# Technical Service Information

## THM 440-T4 INTERMITTENT ENGINE STALL ON COAST DOWN

Figure 1

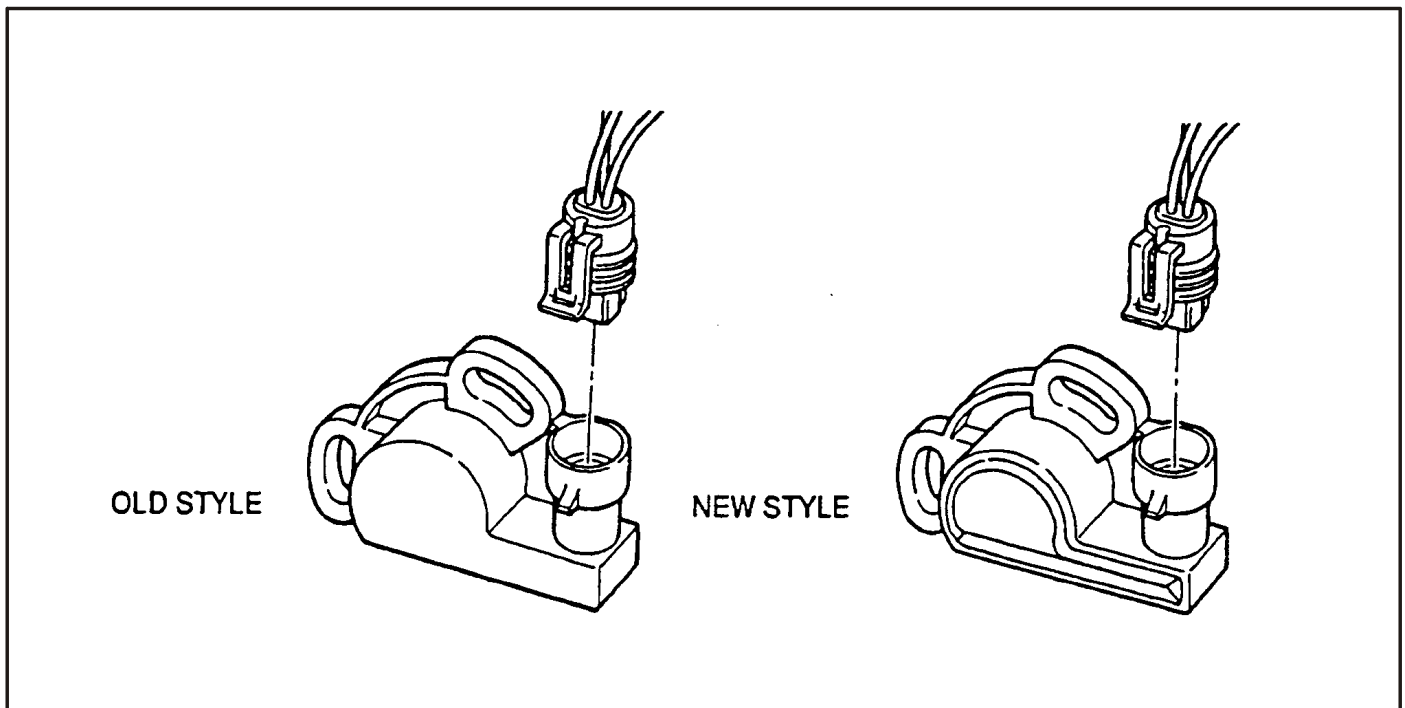
**CORRECTION:** (1) For 1990-1991 vehicles only, visually inspect the TPS. If the TPS is the old style, replace it with Part Number 17112609 (SEE FIGURE 1).

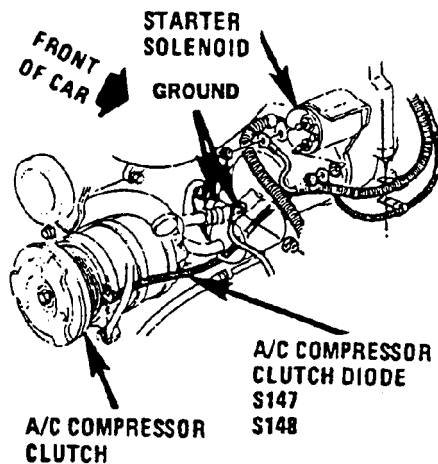
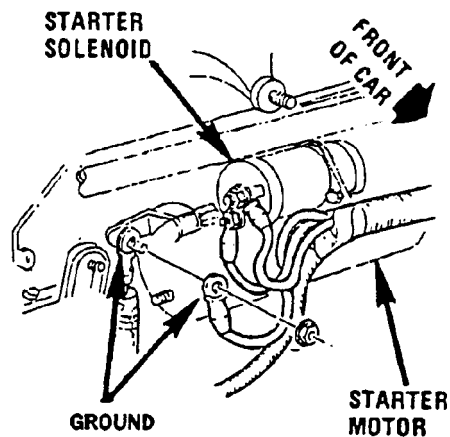
(2) Relocate the ground connection near the starter. That is, remove the ground cable and clean the ring terminal and block with a wire brush (SEE FIGURE 2). Replace the starter mounting bracket and stud Part Numbers 3538914 and 3537885. Reinstall the ground cable.
